1959-1963 DANDENONG ROAD & 75 BEDDOE AVENUE, CLAYTON

Acoustic Report for Town Planning Application

DOC. REF: V1491-01-P ACOUSTIC REPORT (R0)
7 AUGUST 2023

Level 4 Communal Terraces

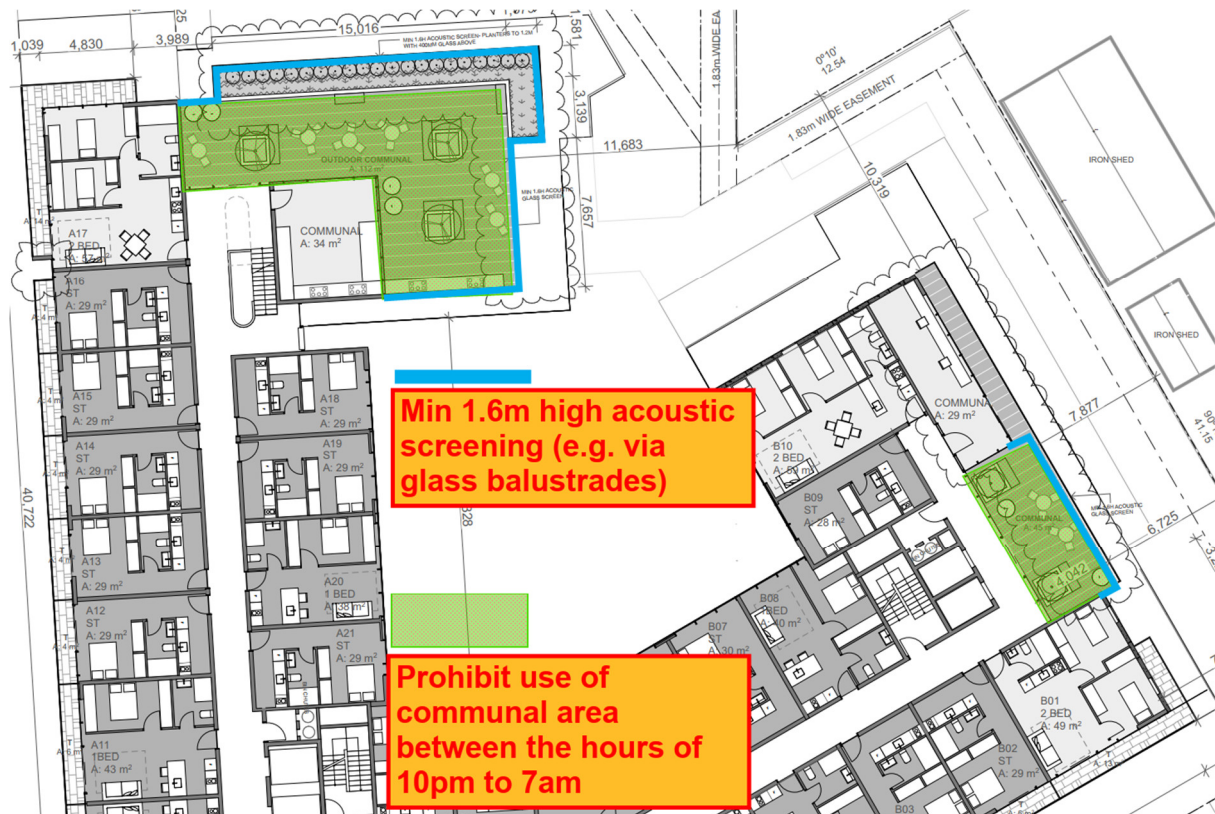
We consider it reasonable to prohibit the use of communal areas overlooking existing off-site sensitive uses. The use of 'inner' communal areas (such as the central courtyard) would only affect on-site sensitive uses and noise impacts from these areas would be a matter for the building management to control.

We also consider it appropriate to install acoustic glass balustrading to assist with minimising noise impacts to off-site sensitive uses.

A summary of our recommendations is presented in the markups below:

Drawing Title:		
GROUND FLOOR PLAN		
Scale: 1:200 @ A1	Date: 20 MAY 2021	
Status: SKETCH	Checked By:	
Project No:	Drawing No.:	Rev.:
18.027	TP.2.2	A
Plot Date:	3/08/2023

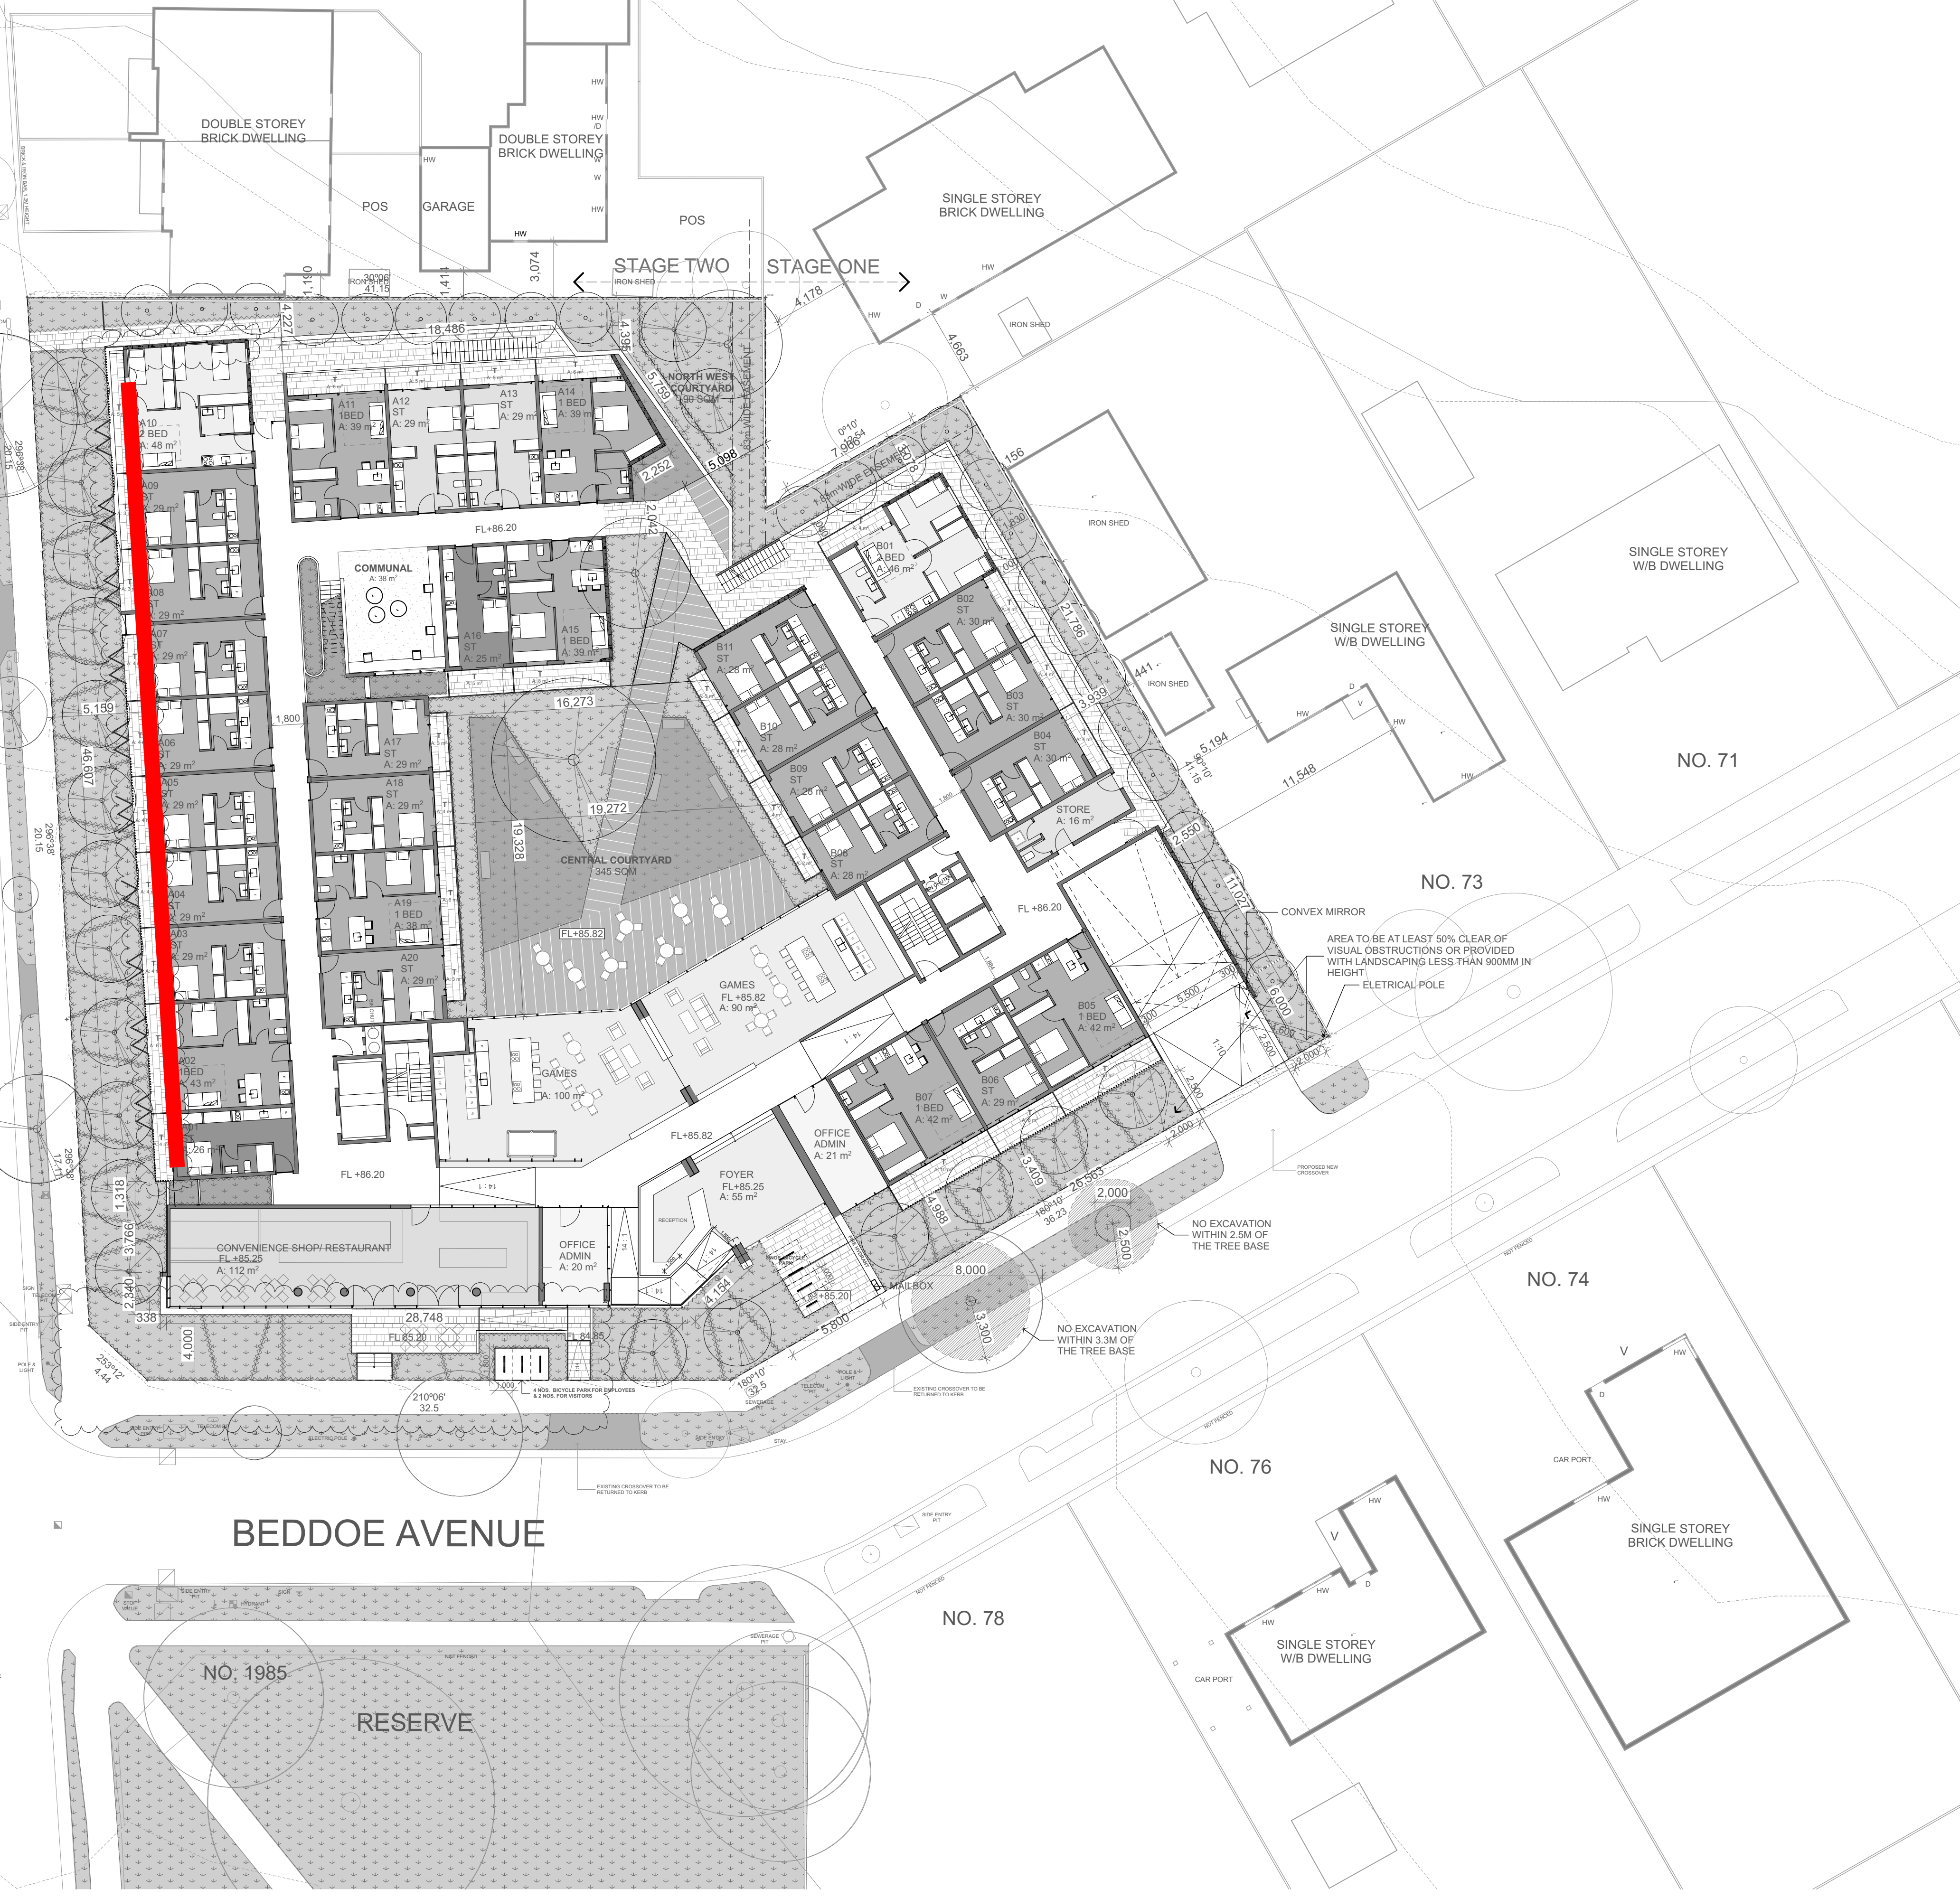
1. LANDSCAPE DETAIL REFER TO LANDSCAPE DRAWING PREPARED BY HANSEN PARTNERSHIP.
 2. DETAIL OF THE BESS REQUIREMENT REFER TO ESD REPORT PREPARED BY SBE.
- EXTENT OF DOUBLE GLAZING REFERED TO IN ENFIELD ACOUSTICS REPORT

Rw33
Double glazed construction with
6.38mm laminated glass / 12mm air gap / 6mm glass

- Windows shall be fitted with bulb seals to perimeter
- Sliding doors shall be fitted with pile seals to perimeter
- Glazing construction indicative only, any other glazing system achieving the Rw requirement (e.g. when certified by proprietary suppliers) is acceptable

Drawing Title: LEVEL 04 PLAN		
Scale: 1:200 @ A1	Date: 20 MAY 2021	
Status: SKETCH	Checked By:	
Project No: 18.027	Drawing No.: TP.2.6	Rev.: A
Plot Date: 3/08/2023

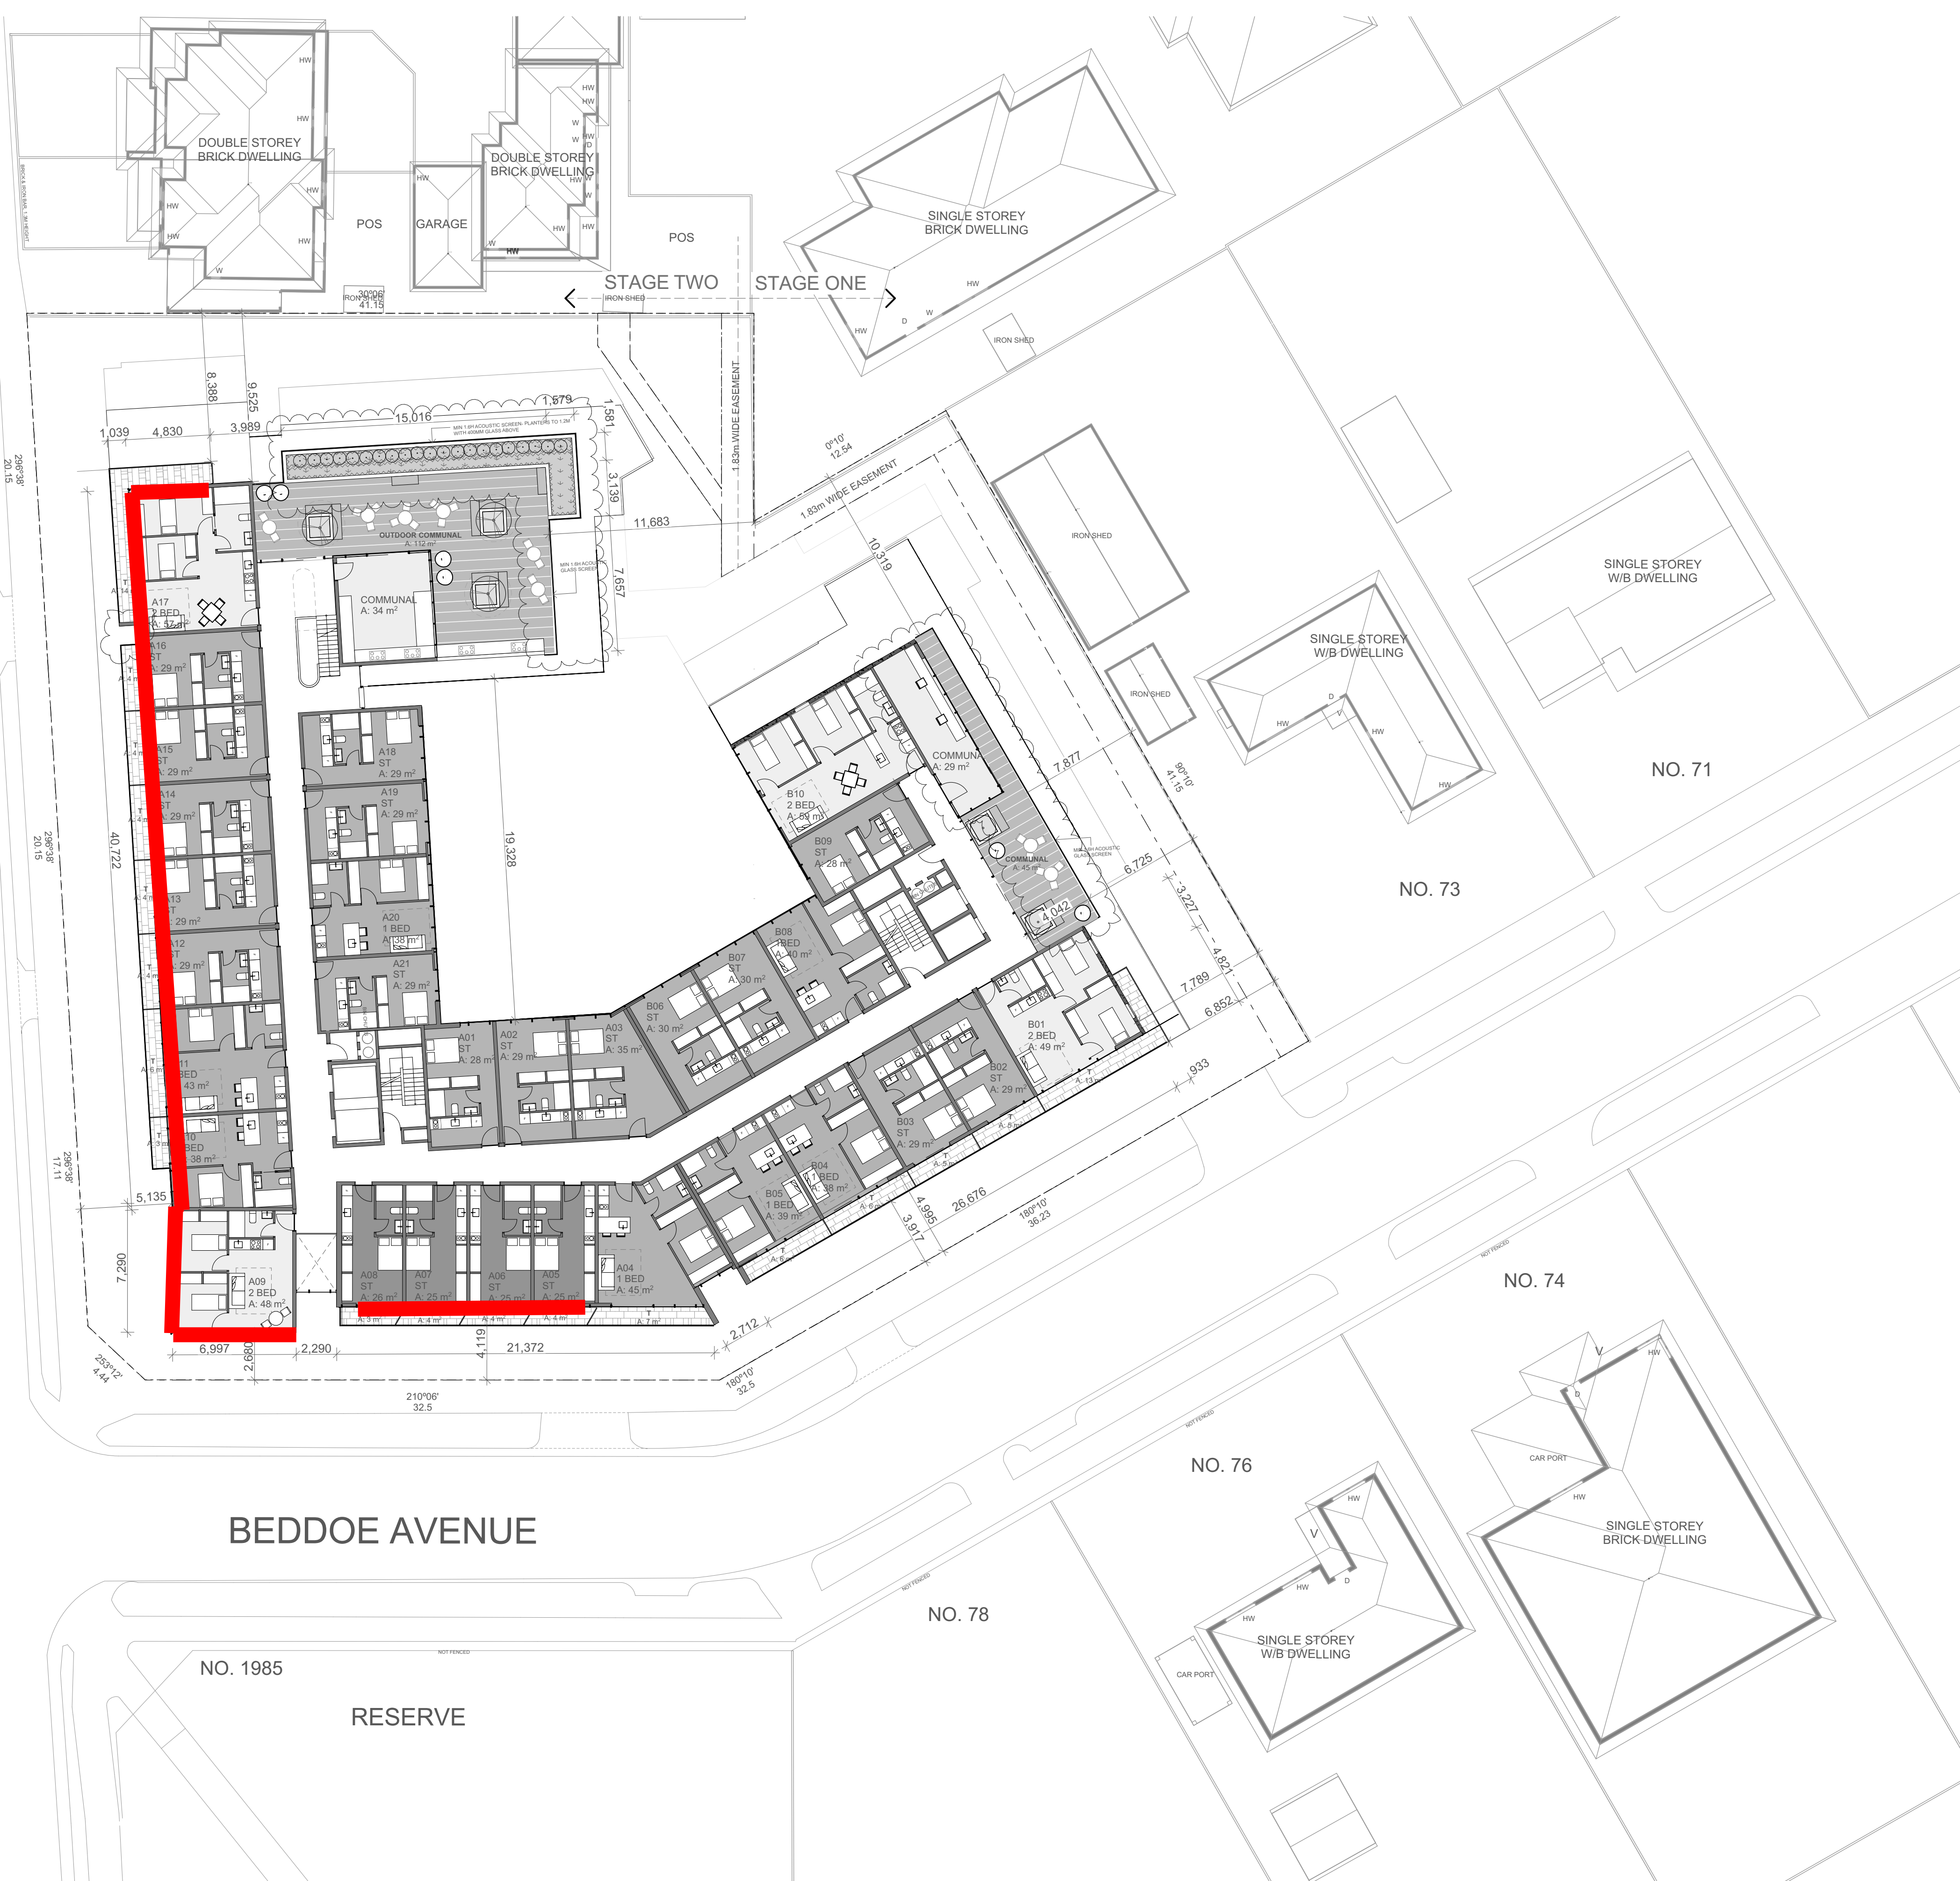
NOTE:
1. LANDSCAPE DETAIL REFER TO LANDSCAPE DRAWING PREPARED BY HANSEN PARTNERSHIP.
2. DETAIL OF THE BESS REQUIREMENT REFER TO ESD REPORT PREPARED BY SBE.
EXTENT OF DOUBLE GLAZING REFERED TO IN ENFIELD ACOUSTICS REPORT

Rw33
Double glazed construction with
6.38mm laminated glass / 12mm air gap / 6mm glass

- Windows shall be fitted with bulb seals to perimeter
- Sliding doors shall be fitted with pile seals to perimeter
- Glazing construction indicative only, any other glazing system achieving the Rw requirement (e.g. when certified by proprietary suppliers) is acceptable
